**PREVOST**

**WARRANTY  
BULLETIN**

**WB15-50**

DATE :	DECEMBER 2015	SECTION :	18 - BODY
EXPIRATION:	DECEMBER 2017		
SUBJECT :	REAR JUNCTION BOX DECAL, R34 RELAY INFO

Fig.3 R34 Relay incorrect 12V information (X3-45 Coach Shown).

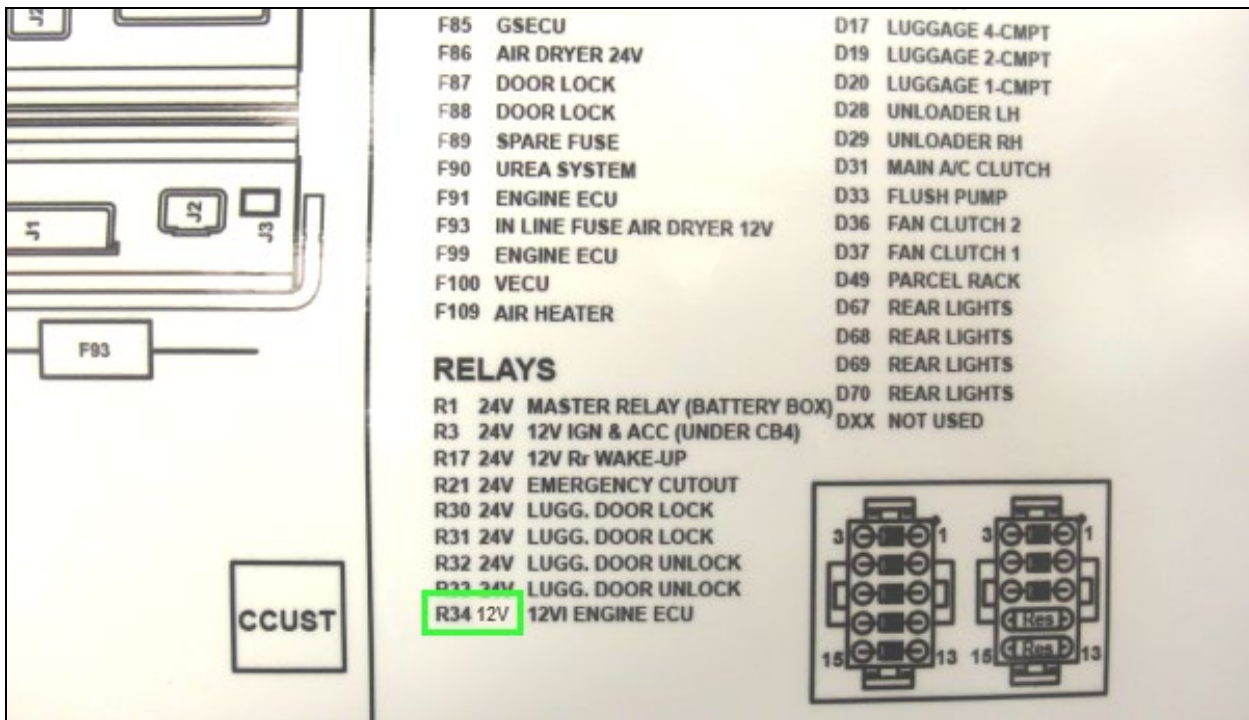
On the vehicles affected by this bulletin the rear junction box decal located in the right engine compartment is displaying incorrect information regarding the R34 relay voltage.

Specifically, the R34 relay should be identified as a 24 volt relay instead of a 12 volt relay.

- On the decal lower right corner, validate that the R34 relay description is inaccurate (Fig.3) and identifies the relay as being a 12 volt relay (12V) instead of a 24 volt (24V).

Fig.5 Decal showing correct R34 voltage (X3 Coach Shown).

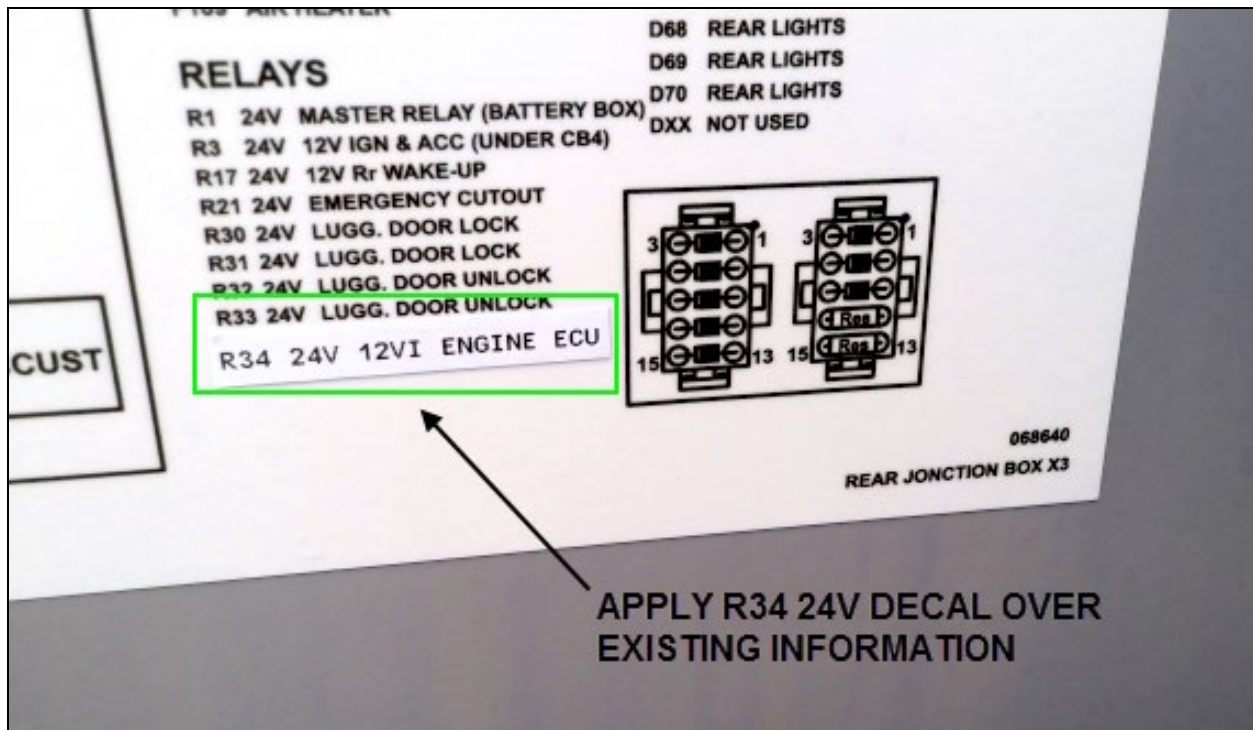
4. Apply the new decal over the existing 12 volt information as shown on Fig.5 and make sure of proper adhesion (apply pressure on the entire area with a plastic card or scraper. In cold weather, apply moderate heat as necessary).

Consequently, all affected vehicles must have a small decal displaying the correct information applied over the rear junction box decal R34 relay description.
